APPENDIX M
PUBLIC CONSULTATION

Claremont Drainage Plan

TPB168152 – Claremont Drainage Plan PIC1 Resident Comment Summary

7. Existing Drainage System Types

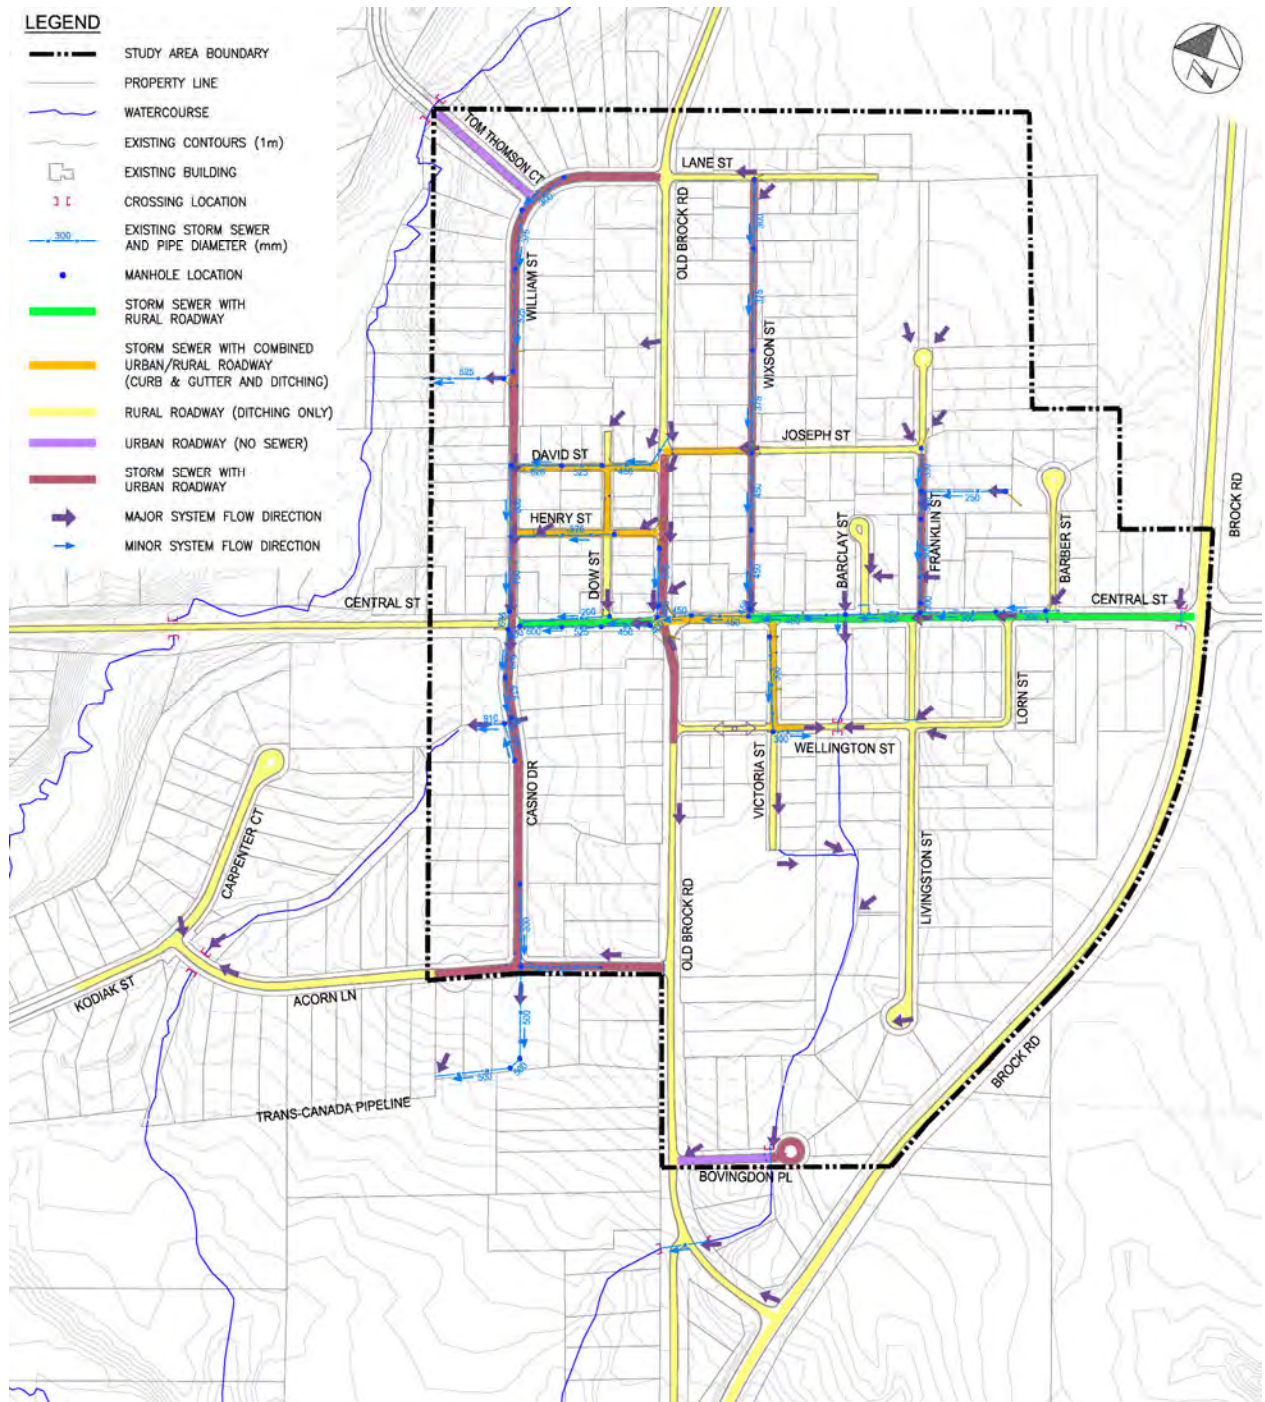
On page 9 of the presentation, you identify Lane St as a rural roadway with ditching. However, if you performed a survey and came down Lane St, you would have seen that street actually does not have a ditch and therefore has no drainage system to support it. I recommend you add "no ditch present" for Lane St on your map on page 14.

On page 9 of the presentation, you identify Lane St as a rural roadway with ditching. However, if you performed a survey and came down Lane St, you would have seen that street actually does not have a ditch and therefore has no drainage system to support it. I recommend you add “no ditch present” for Lane St on your map on page 14.

13. Overall Drainage System Performance

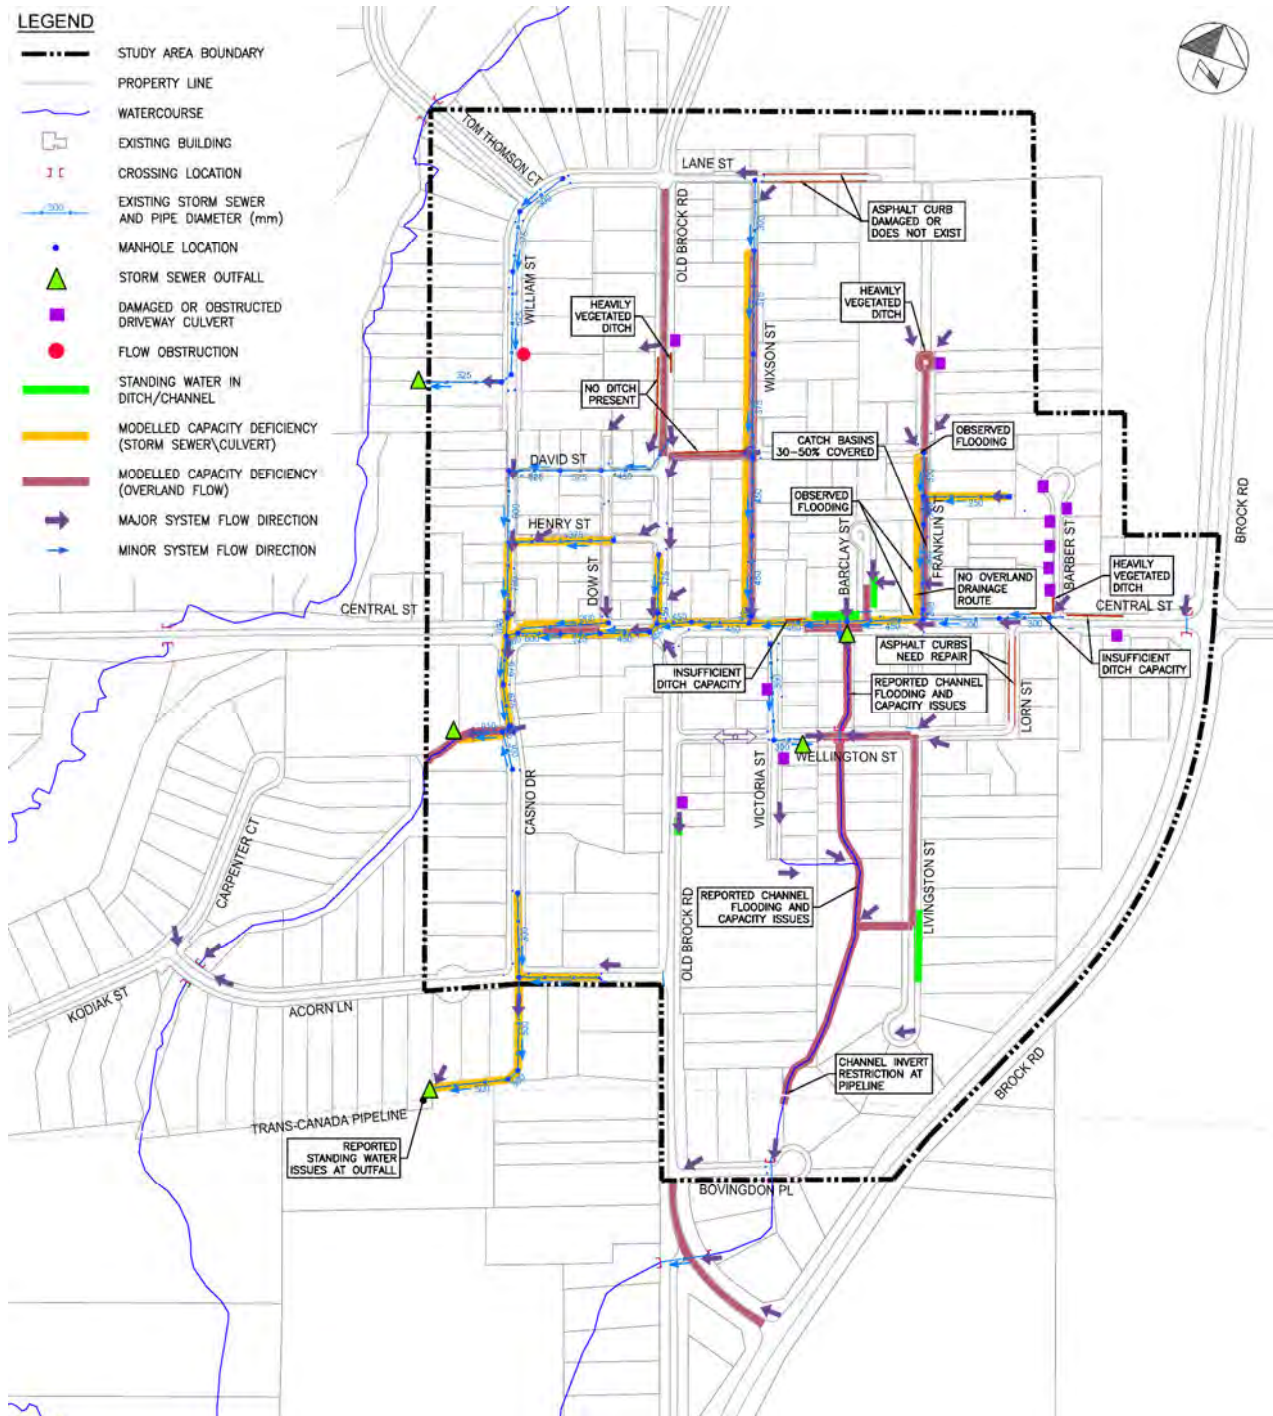
In addition, your rainfall data models on page 10 are flawed in their analysis, since you failed to provide sufficient data for the houses in close proximity to the perimeter of the study area boundary – especially the houses on the north end of the perimeter since water flows North to South in Claremont. Since you only collected the direction of the flow of water within your study area boundary, you do not have an accurate representation on which to base your decision of what kind of support is needed and where. For example, you include the field that flows into Frank St and Barber St but failed to do so for Lane St which has a significant amount of field north of it. This plays a considerable role in the water flow and subsequent support required for the surrounding properties. It also heavily biases your conclusions on what streets require support. This affects all the modeling prepared on pages 12, 13, and 14.
